**RE: NMED SWQB Comments August 24, 2018 and EPA Comments September 26, 2018**

Enclosed you will find one (1) electronic copy of the revised Lee Ranch Mine (LRM) Use Attainability Analysis (UAA) report for the streams located in the vicinity of the LRM. The UAA report has been revised to address the technical review comments provided by New Mexico Environmental Department (NMED) Surface Water Quality Bureau (SWQB) on 8/24/2018 and Environmental Protection Agency (EPA) on 9/26/2018. Peabody Natural Resources Company (PNRC) believes that this UAA provides substantial evidence to support the modification of the designated use of the San Isidro Arroyo and its tributaries. Also accompanying this letter is PNRC's response to the technical review comments from NMED SWQB and EPA.

### NMED Surface Water Quality Bureau

### USEPA Region 6

**Figure 2: Lee Ranch Mine UAA - Topography**

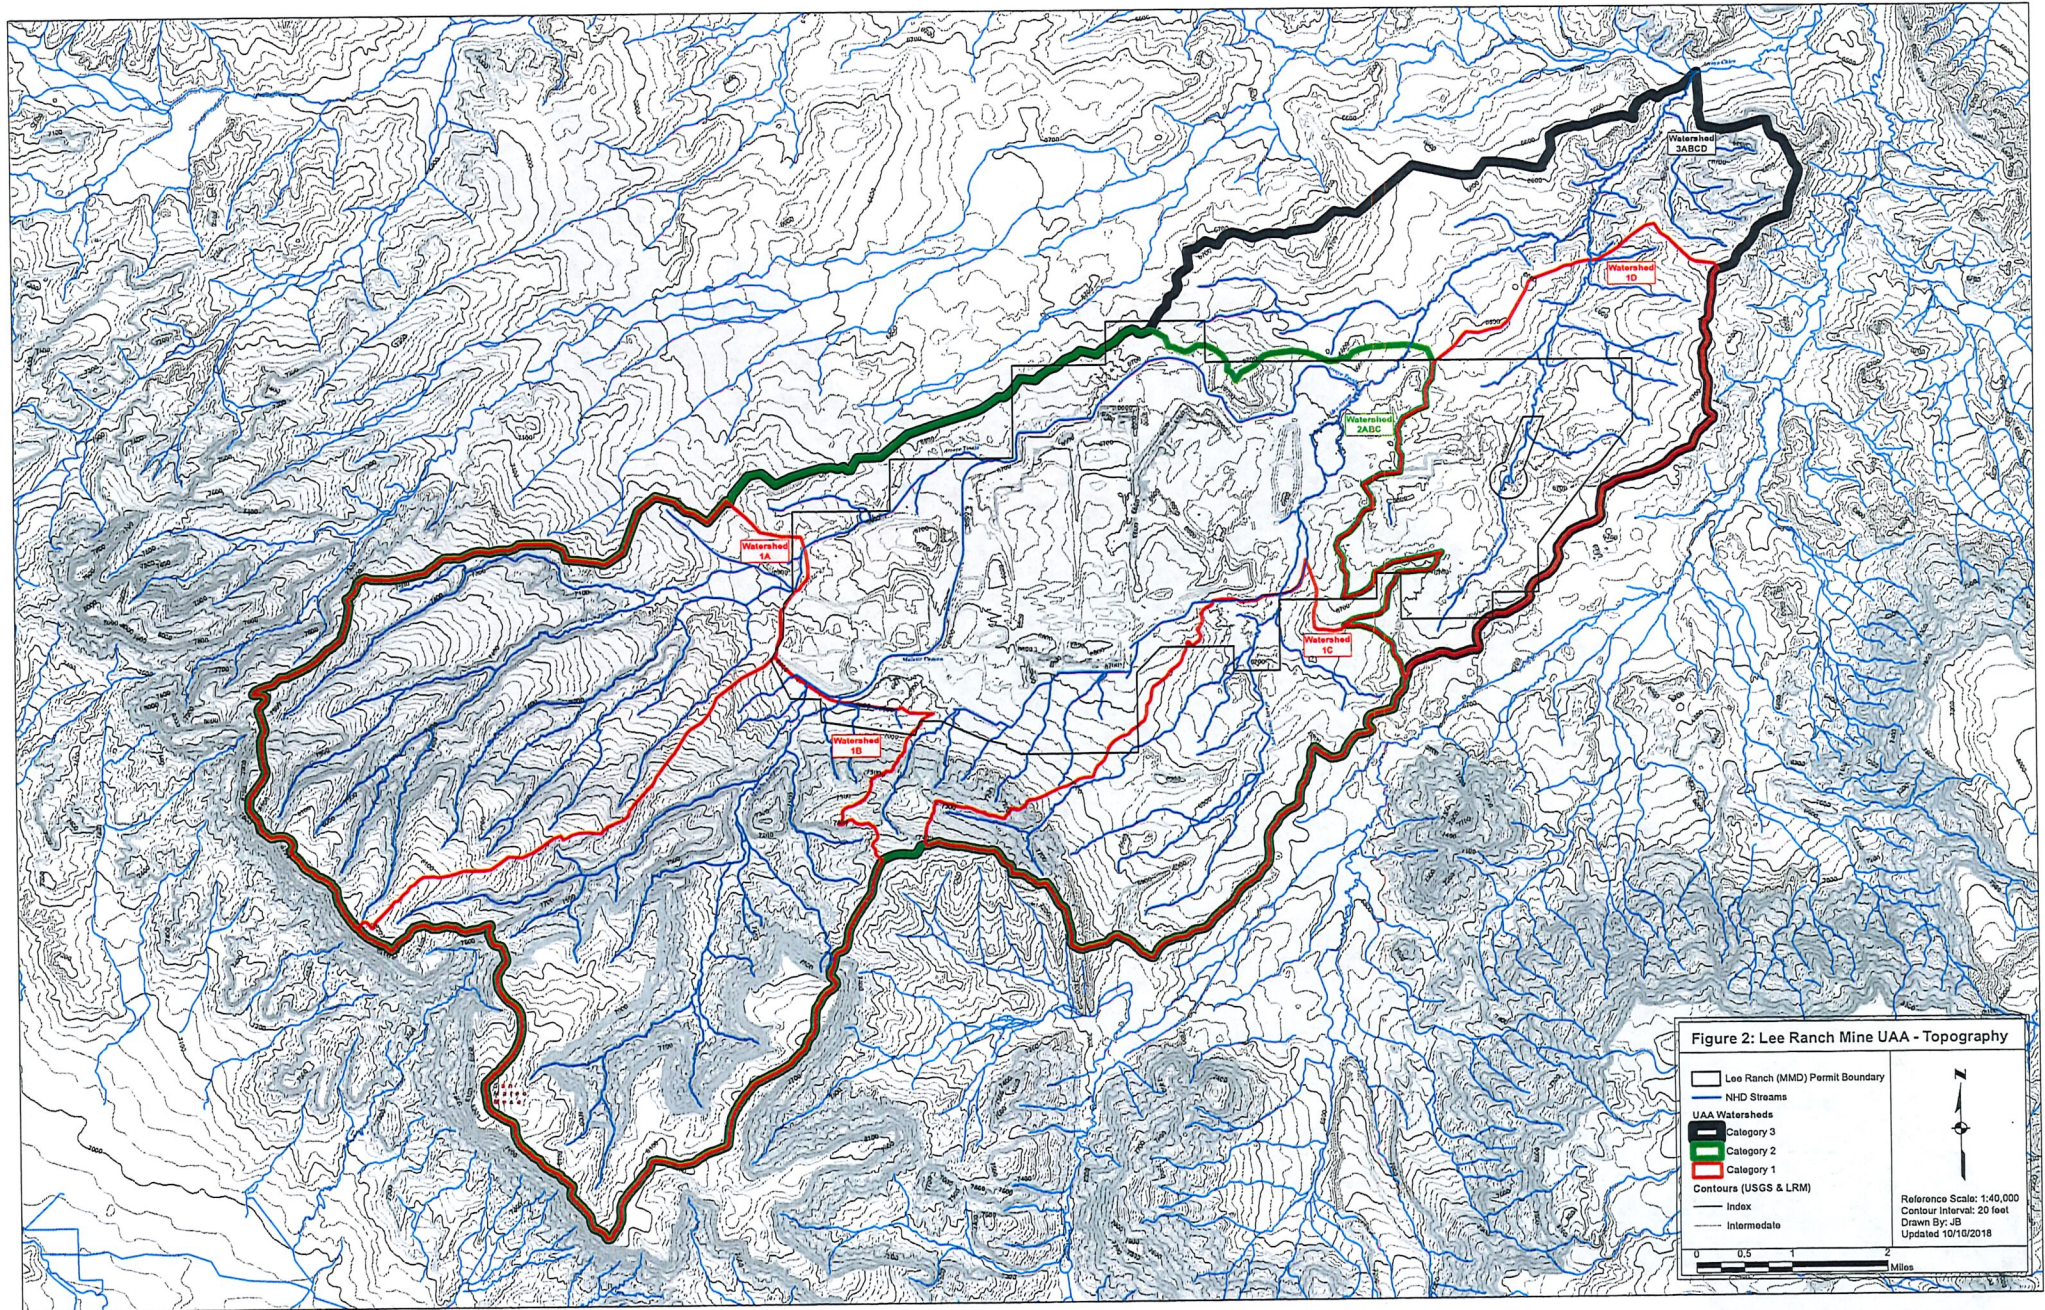
*Thirteen springs were identified within and around the Lee Ranch Mine permit (New Mexico Mining and Minerals Division (MMD) Permit 19-2P) boundary. What is the MMD permit boundary in the context of the Lee Ranch Mine and larger San Isidro Arroyo watershed? Consistent with prior comments, a map that clearly identifies the MMD permit boundary would provide some context.*

The Lee Ranch Mine MMD permit and mining disturbance boundaries were previously included on Figure 1 of the original submittal. The permit boundary is now included on Figure 2 Topography Map, Figure 3 Overview Map (previously Figure 1), Figure 11 Subwatershed 2ABC and 3ABCD Map, and the interactive pdf map (Figure 0). The mining disturbance boundary is included on Figures 3, 11, and the interactive map (Figure 0).

Figure 4. Mean daily discharge (cubic feet per second) at the USGS Arroyo Chico Gaging Station (08340500) located downstream of the San Isidro drainage basin.

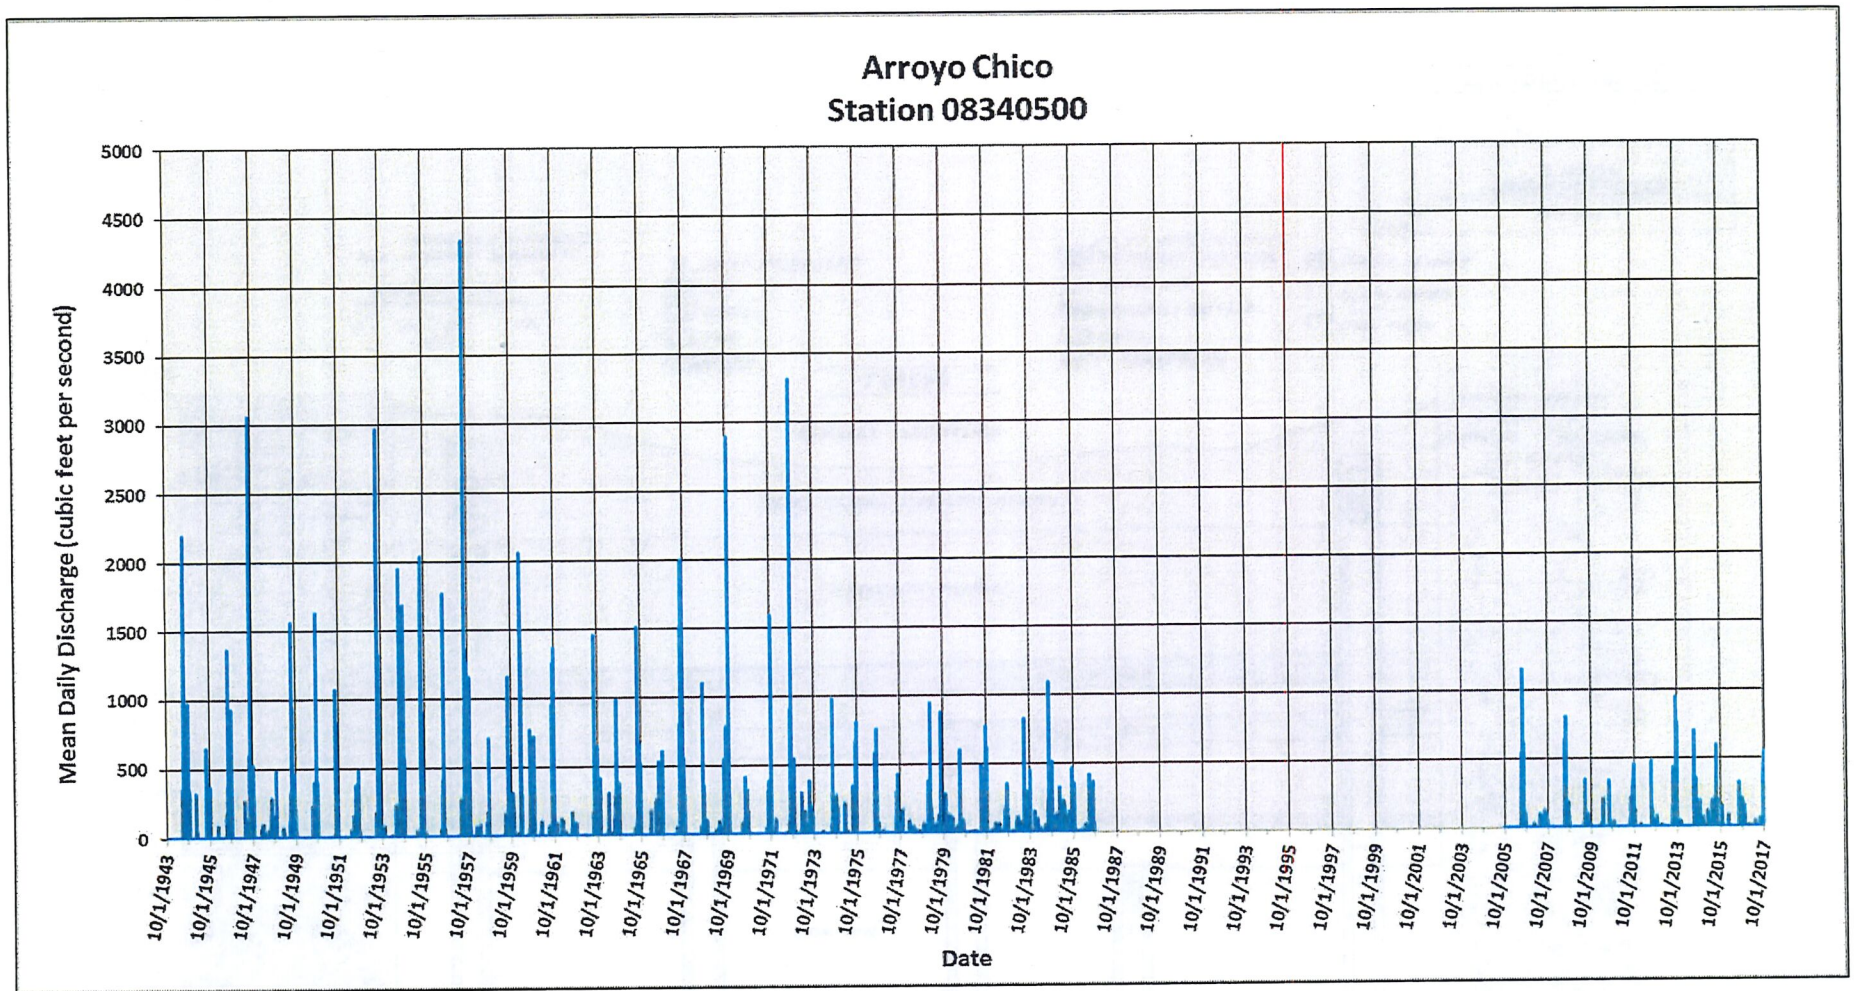
*Both the narrative and images in Figure 4 are significant. No further comment is necessary.*

**Figure 7: Lee Ranch Mine UAA - Subwatershed 1A**

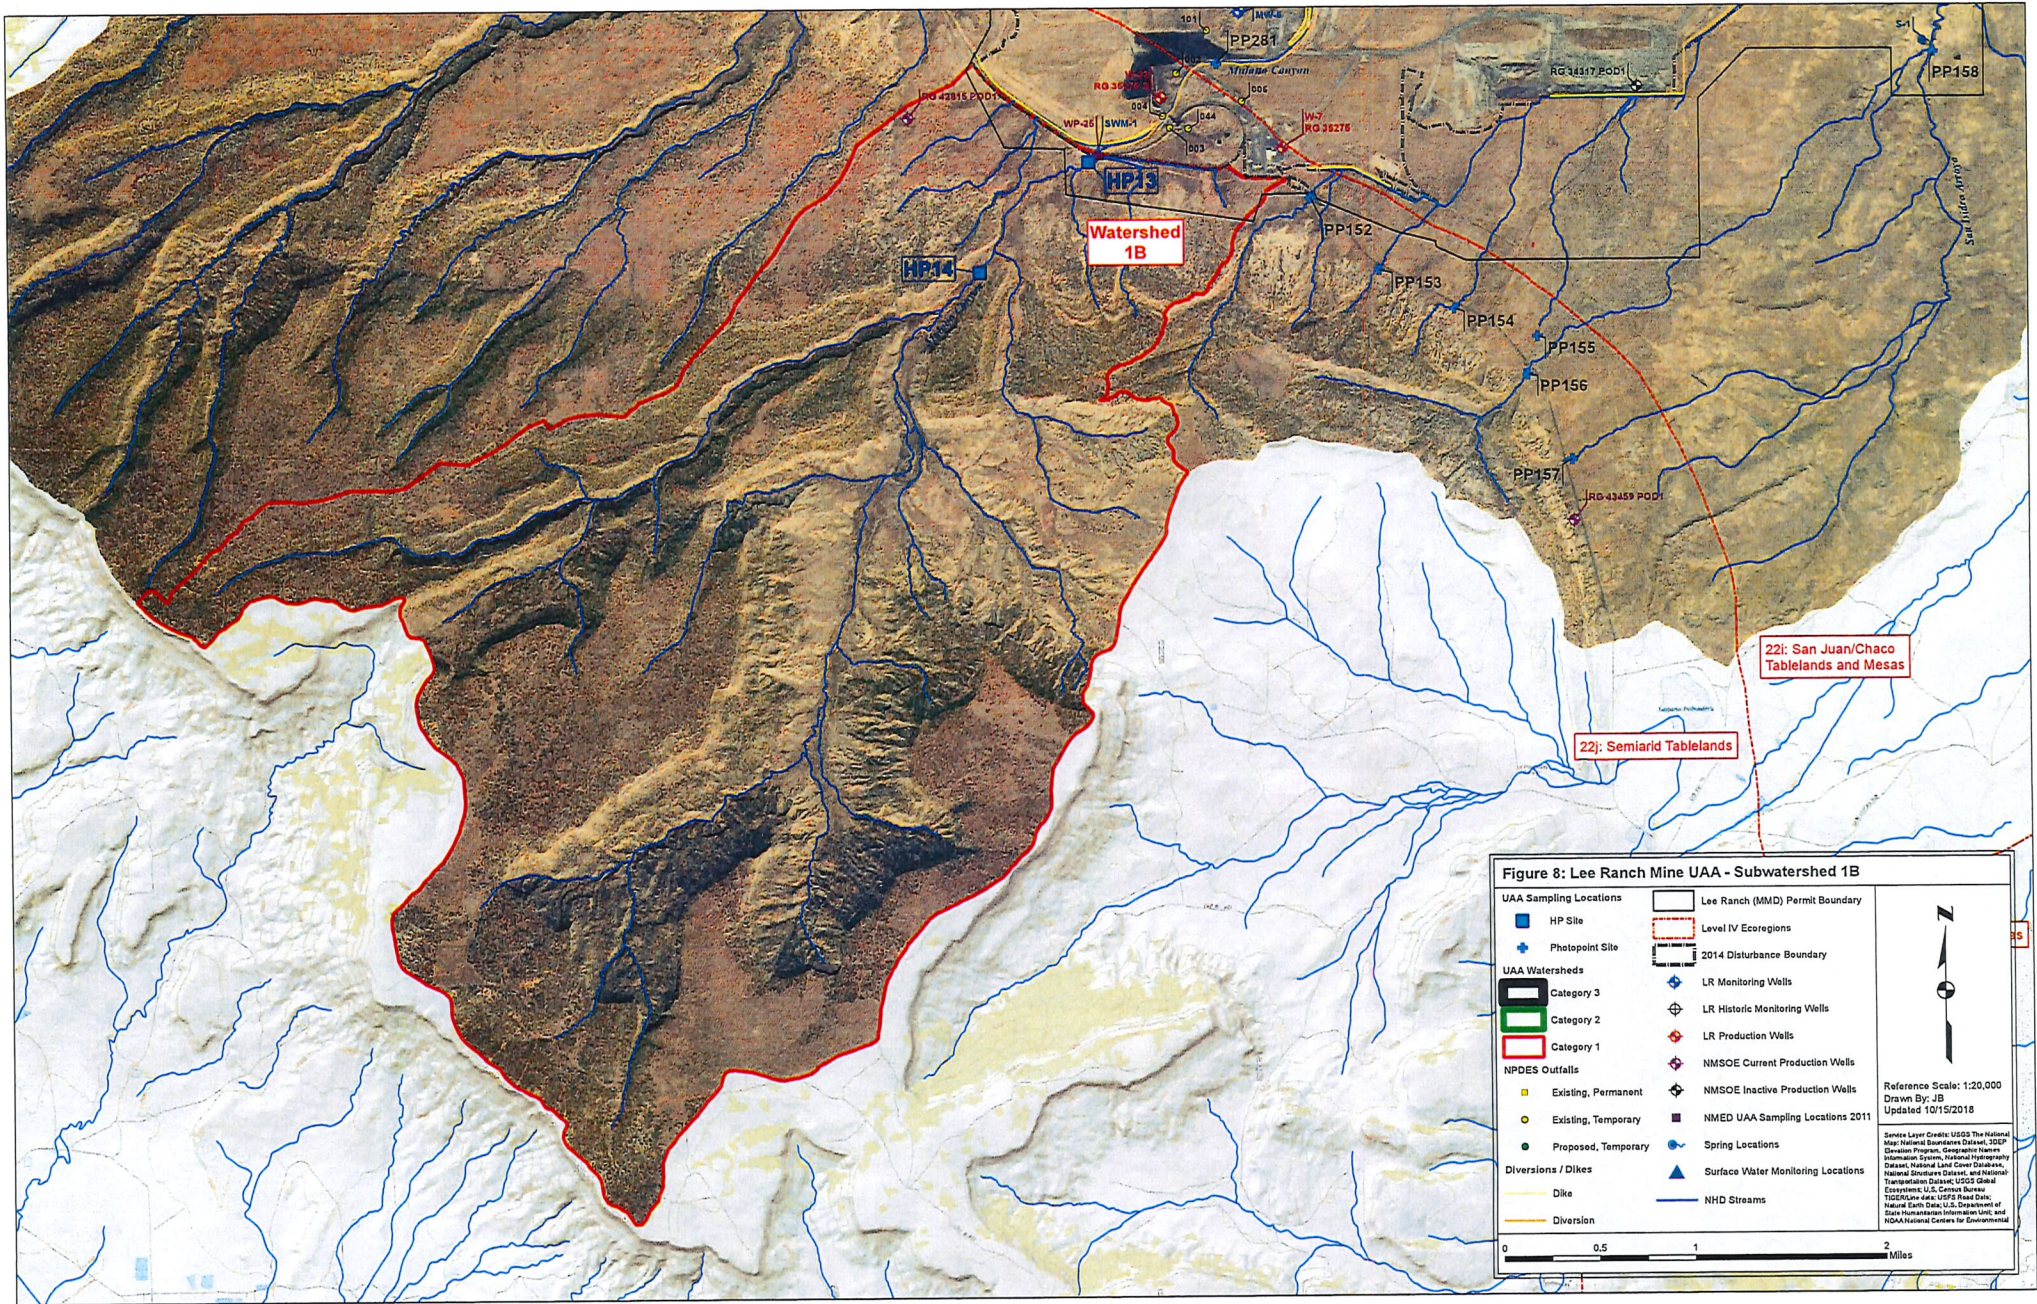
*The narrative here is informative. But as noted in prior recommendations, it would be helpful to supplement the narrative and Figure 6 with an image of the waters as they run through Mulatto Canyon and HP and photo point site locations. This would give context to the Level IV Ecoregion (22j) and related elevation changes (without dense colors and locations used in Figure 1).*

*These images have been incorporated into Figure 7 Subwatershed 1A and Figure 8 Subwatershed 1B.*
